LEDA Manorstead Pty. Ltd.  
Attn: Mr. Reg van Rij  
Suite 14, Level 1  
46 Cavill Avenue  
Surfers Paradise Qld 4217

23<sup>rd</sup> October, 2015

I refer to your e-mail and associated attachments of the 15<sup>th</sup> October requesting further advice on structural and fauna movement/management issues related to provision of the 50 m wide dual purpose (i.e. drainage/fauna movement) corridor on the Cobaki site.

I refer to your request for independent advice regarding the efficacy and potentially utility of underpass configurations currently being considered in the context of Condition 63 of the development consent for the proposed Cobaki residential estate in the Tweed Local Government Area of northern NSW.

DUNBOGAN TIP ROAD UPGRADE KOALA MITIGATION MEASURES TYPICAL UNDERPASS			
Work Order Number:	Drawing Number:	Sheet	Size:
Sheet 1 of 1	Revision:	A1	A1

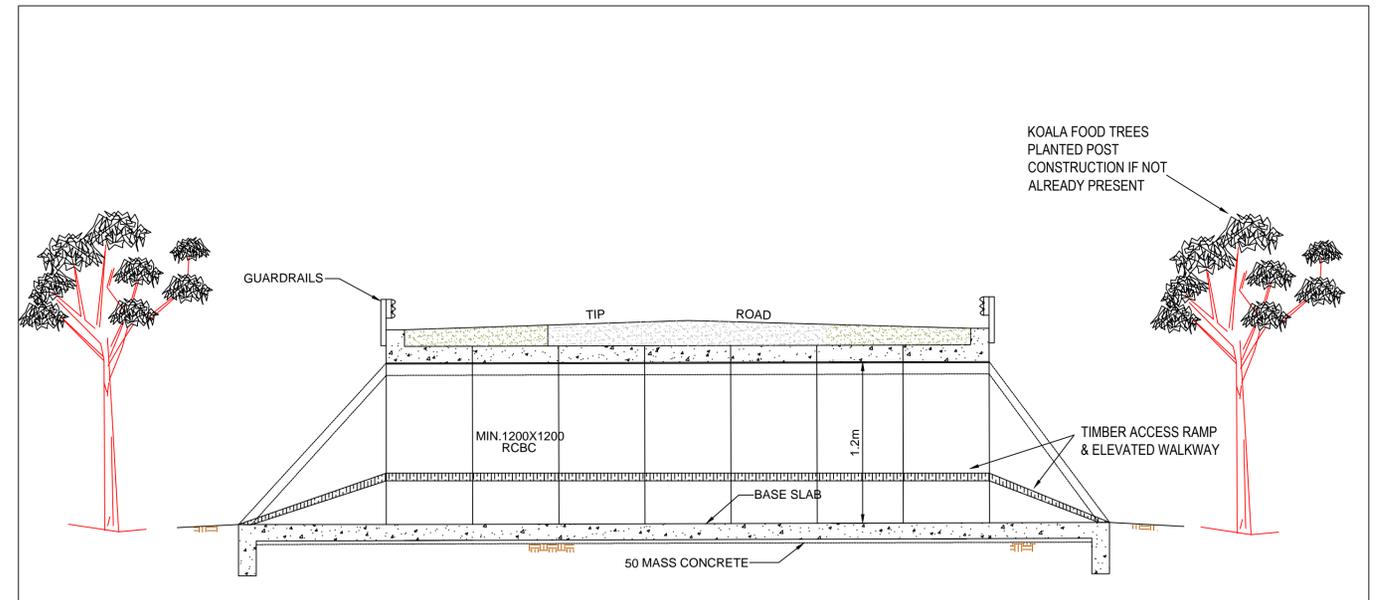
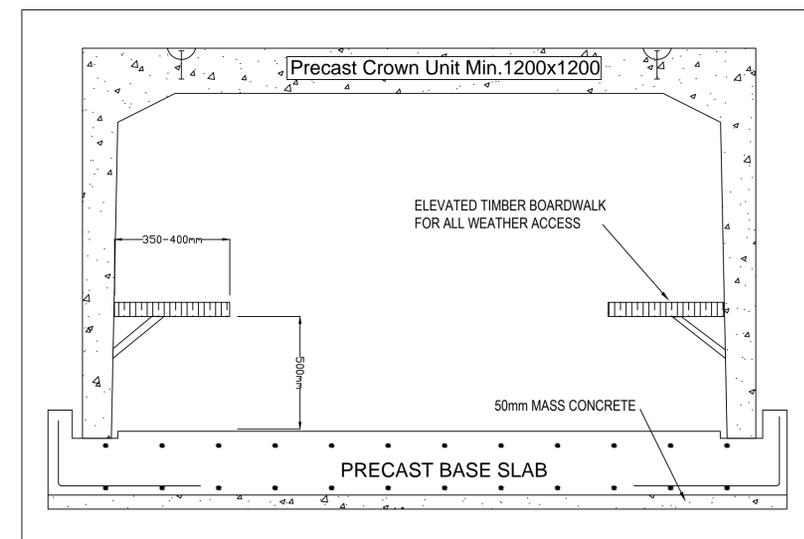
the presence of water. While aspirations to regular underpass maintenance are often espoused in management documents, such necessary actions are rarely (if ever) undertaken and even more difficult to monitor and enforce. The use of shelves thus ensures that the potential for all-year round dry access through underpass structures can be maximized. For your information I have attached a drawing of the intended outcome as recently implemented by Port Macquarie Hastings Council.
